Report to the Future Melbourne (Planning) Committee

Planning Scheme Amendment C190 Arden-Macaulay

2 August 2016

Panel Report pursuant to Section 25 of the Act
Melbourne Planning Scheme Amendment C190
Arden–Macaulay Structure Plan Implementation

PANEL'S RECOMMENDED DDO MAP1 STREET WALL HEIGHT AND SETBACKS

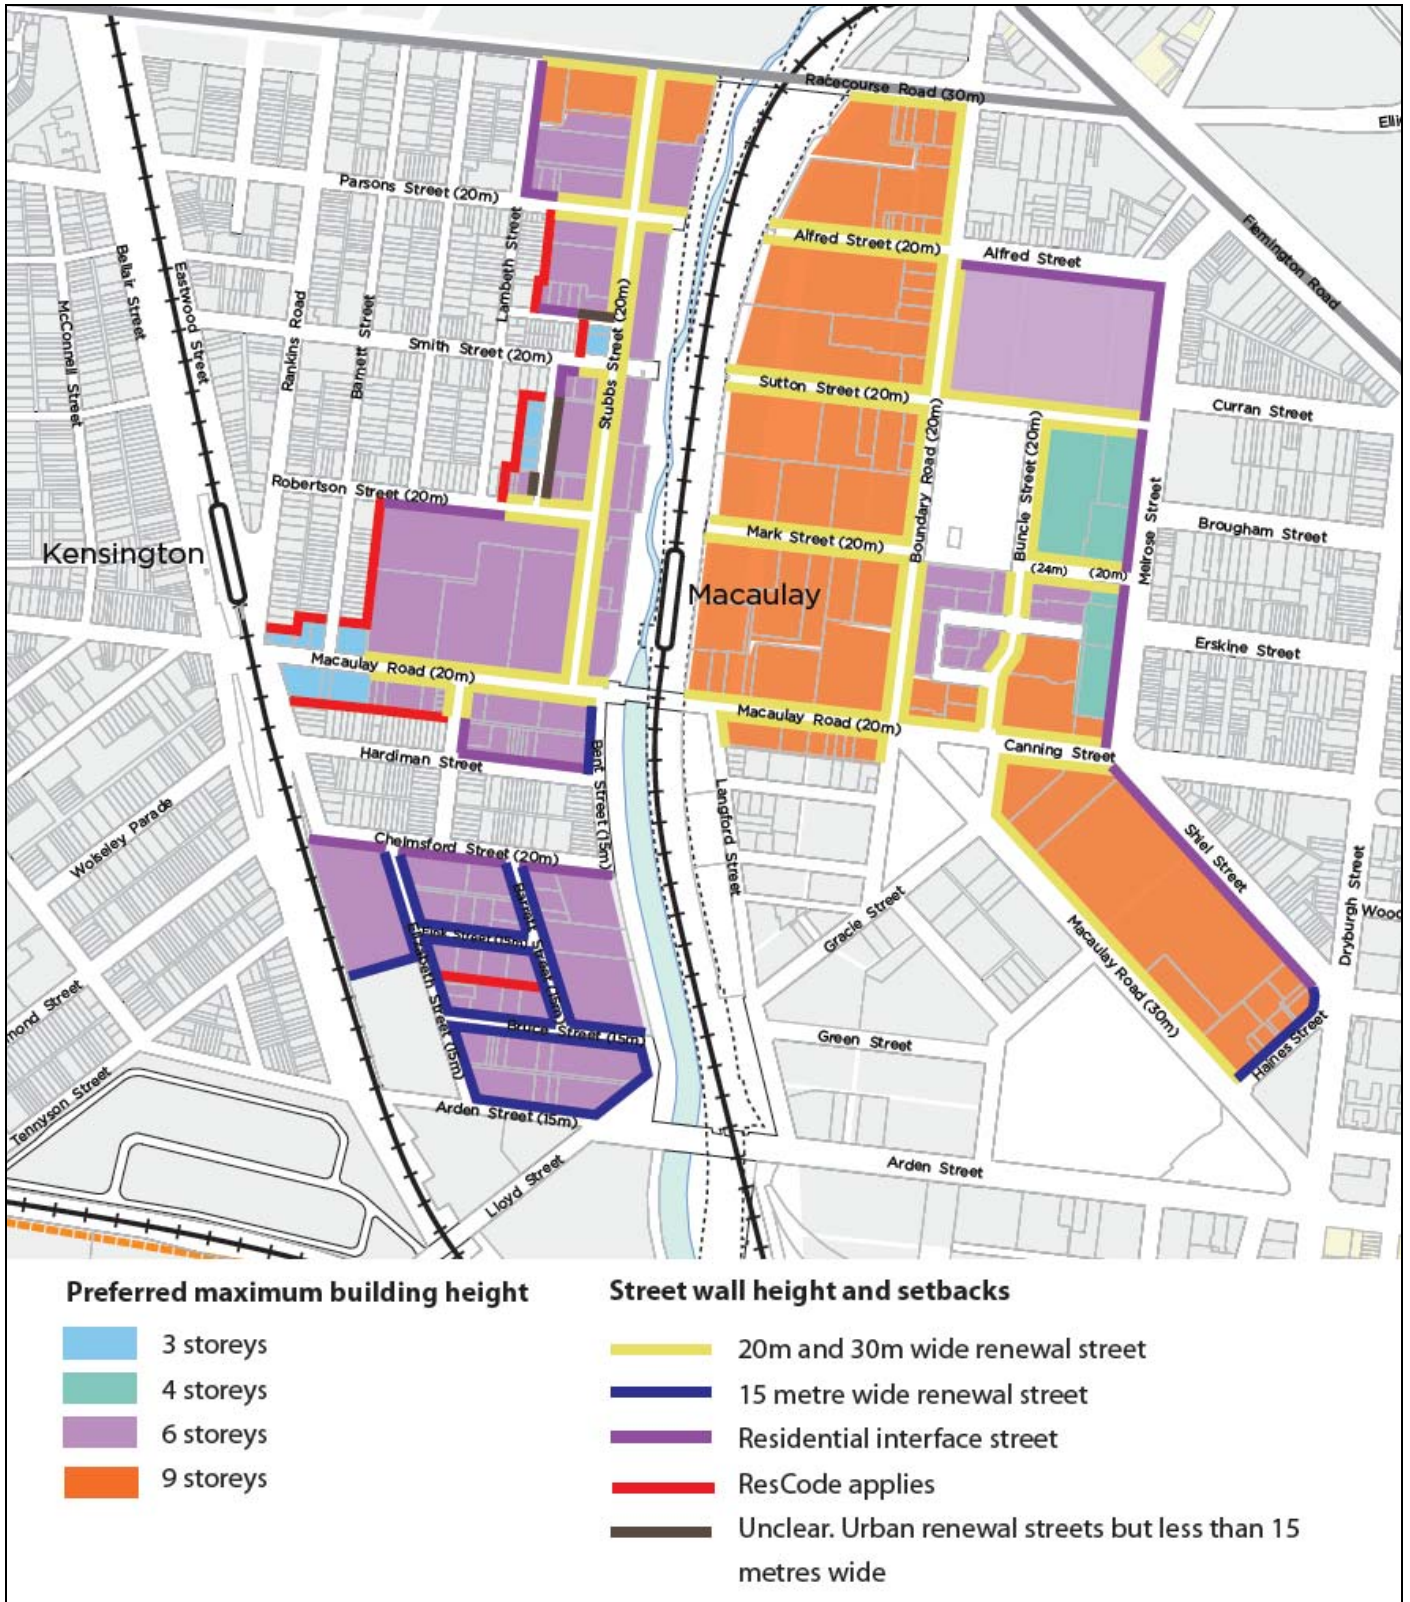
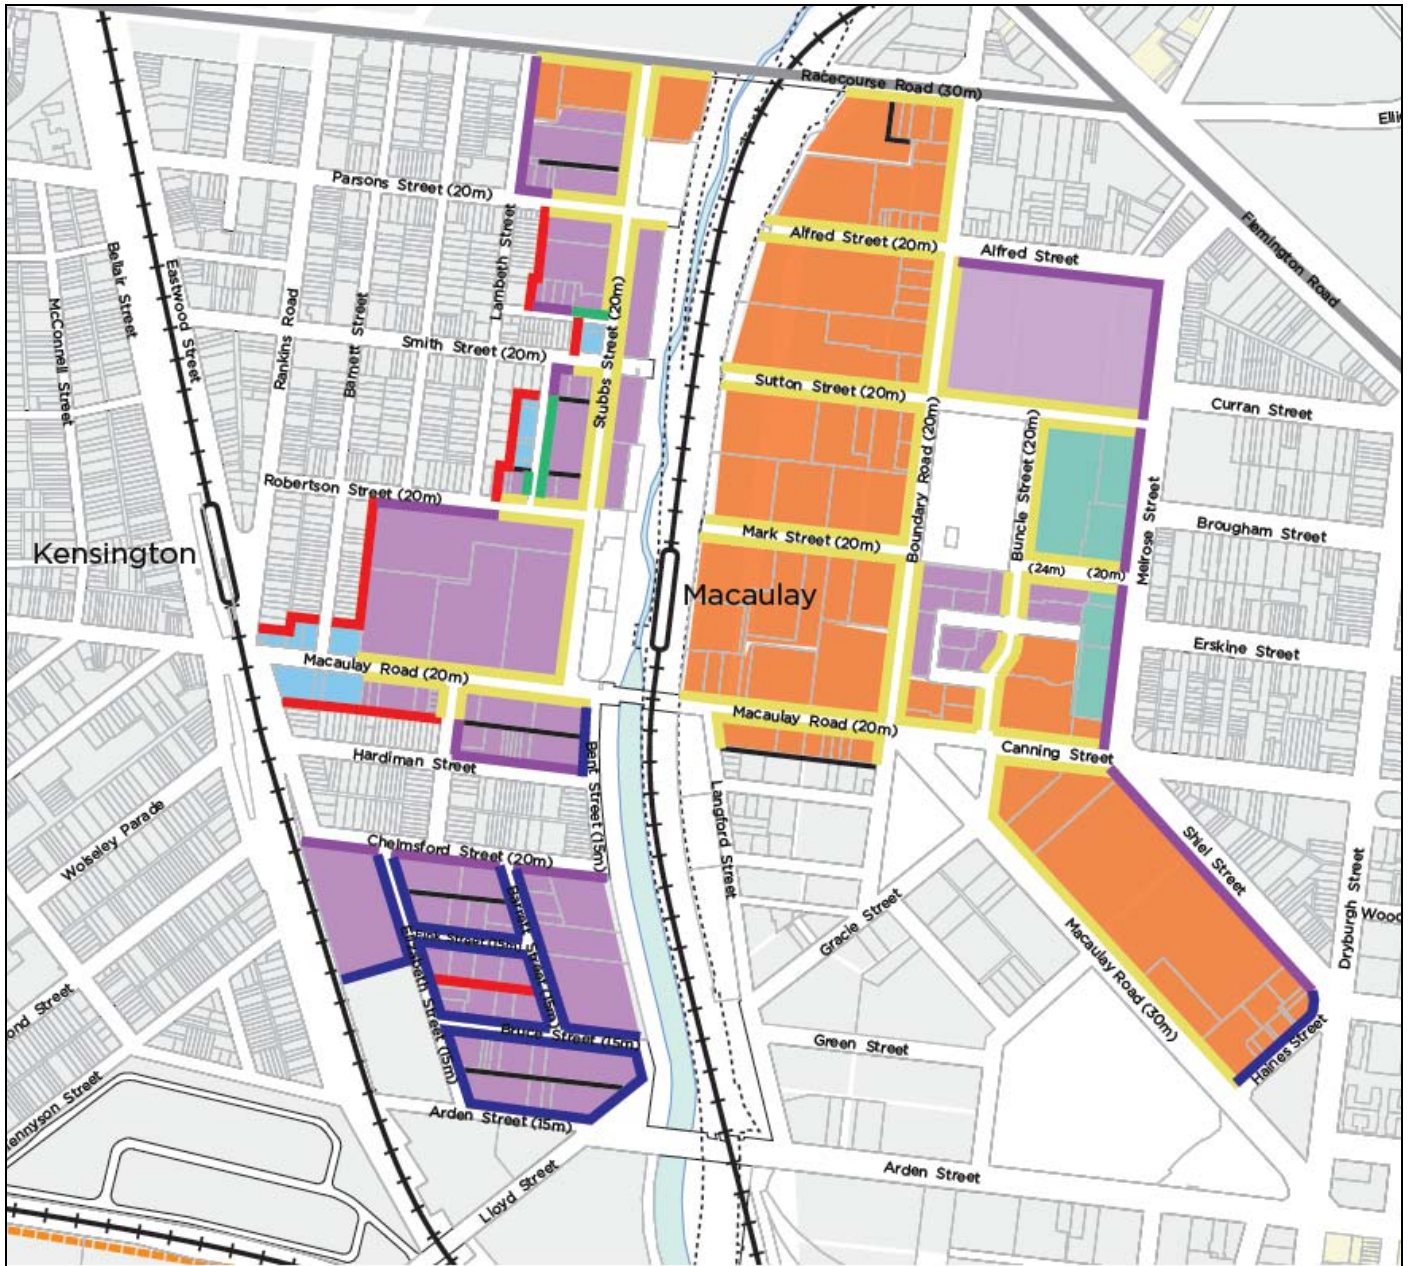
Comment [GP19]: Replaced by Table 3 and map 1

MANAGEMENT'S RECOMMENDED DDO MAP1 STREET WALL HEIGHT AND SETBACKS

Figure 4

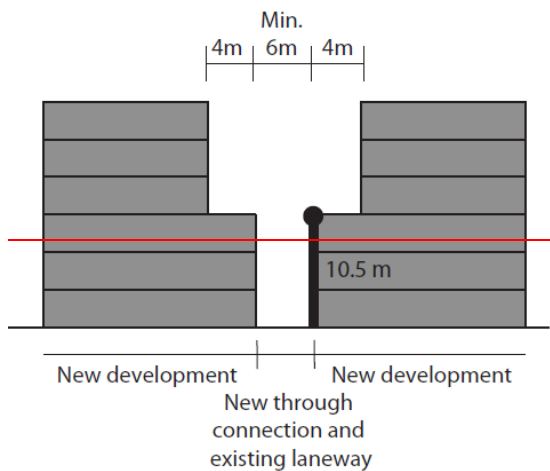
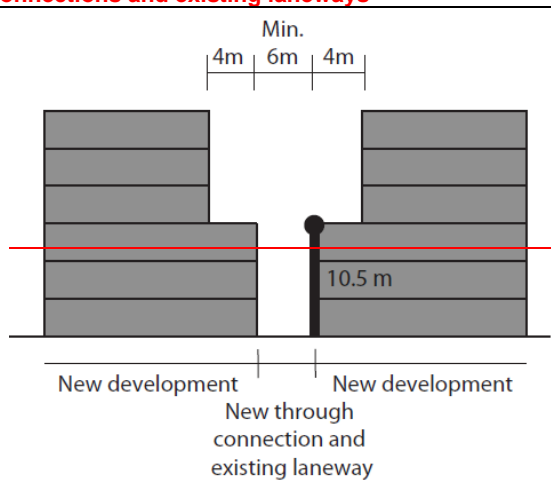
Ms Burnett for Real Estate Prosperity Pty Ltd. submitted that Figure 4 of DDO60 should apply only to laneways and through connections which warrant pedestrian amenity controls. The property of 476 square metres at 114-116 Haines Street contains a 4-59 metre service laneway which Ms Burnett submitted does not contribute to the overall connectivity of the broader area and is not identified within the Structure Plan.

Figure 9

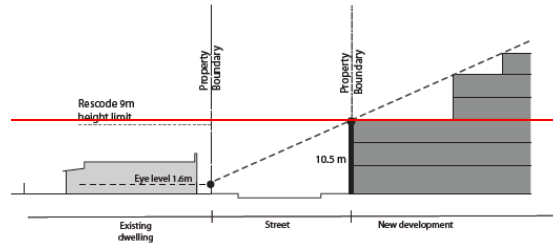
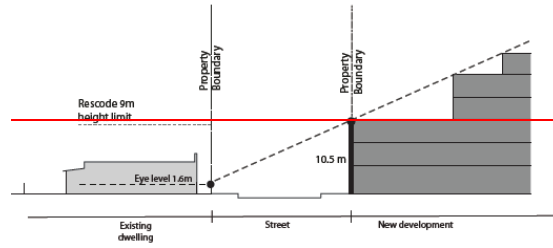
Mr Chamberlain on behalf of the owners of 89-96 Stubbs Street submitted that Thompson Street, which forms the western boundary of the site is not characterised by low-scale development. It is currently in the Industrial 3 Zone, but there is one existing dwelling opposite the site. It is a non-conforming land use. Mr Chamberlain submitted that the more stringent height and setback provisions set out in Figure 9 of DDO60 should not apply to this interface.
